State of New Mexico
Energy, Minerals and Natural Resources

Form C-103
Revised July 18, 2013

WELL API NO. 30-025-48769
5. Indicate Type of Lease STATE ☒ FEE ☐
6. State Oil & Gas Lease No.
7. Lease Name or Unit Agreement Name Prometheus State Com
8. Well Number 174H
9. OGRID Number 372043
10. Pool name or Wildcat TRIPLE X; BONE SPRING, WEST
4. Well Location Unit Letter <u>O</u> : <u>841</u> feet from the <u>South</u> line and <u>1461</u> feet from the <u>East</u> line Section <u>22</u> Township <u>24S</u> Range <u>33E</u> NMPM County <u>Lea</u>
11. Elevation (Show whether DR, RKB, RT, GR, etc.) 3552 GR

Tap Rock requests the following:

WELL LOCATION AND ACREAGE DEDICATION PLAT

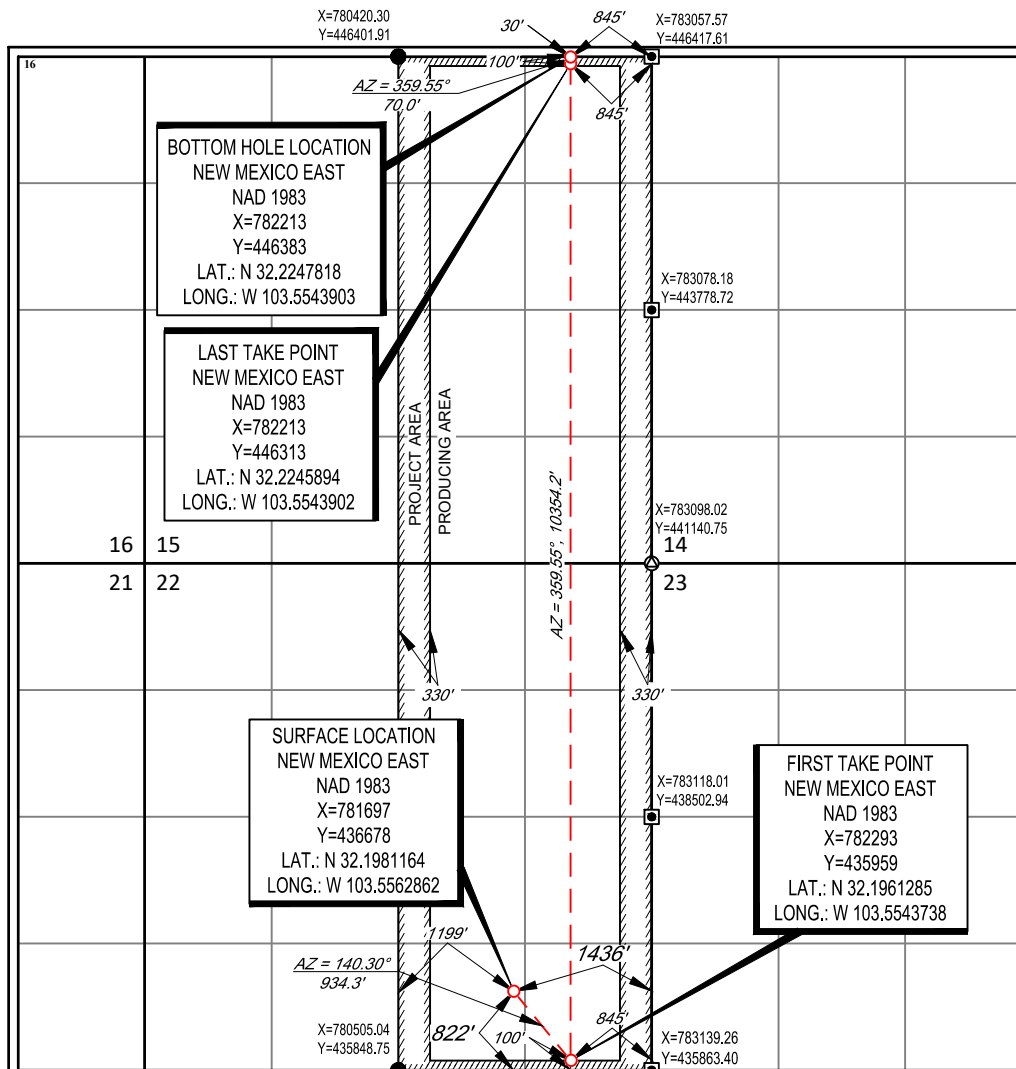
1. Change the SHL to O-22-24S-33E, 822' FSL 1436' FEL, Lea County, NM. Lat: 32.1981164, Long: -103.5562862
2. Change the BHL to A-15-24S-33E, 30' FNL 845' FEL, Lea County, NM. Lat: 32.2247818, Long: -103.5543903
3. Change the spacing unit size to 640 acres compromised of Units A B G H I J O P 15-24S-33E and A B G H I J O P 22-24S-33E based on Prometheus State Com 144H (API 30-025-48765) as the defining well.

UL or lot no.	Section	Township	Range	Lot Idn	Feet from the	North/South line	Feet from the	East/West line	County
0	22	24-S	33-E	-	822'	SOUTH	1436'	EAST	LEA

UL or lot no.	Section	Township	Range	Lot Idn	Feet from the	North/South line	Feet from the	East/West line	County
A	15	24-S	33-E	-	30'	NORTH	845'	EAST	LEA

¹² Dedicated Acres 640	¹³ Joint or Infill	¹⁴ Consolidation Code	¹⁵ Order No.
--------------------------------------	-------------------------------	----------------------------------	-------------------------
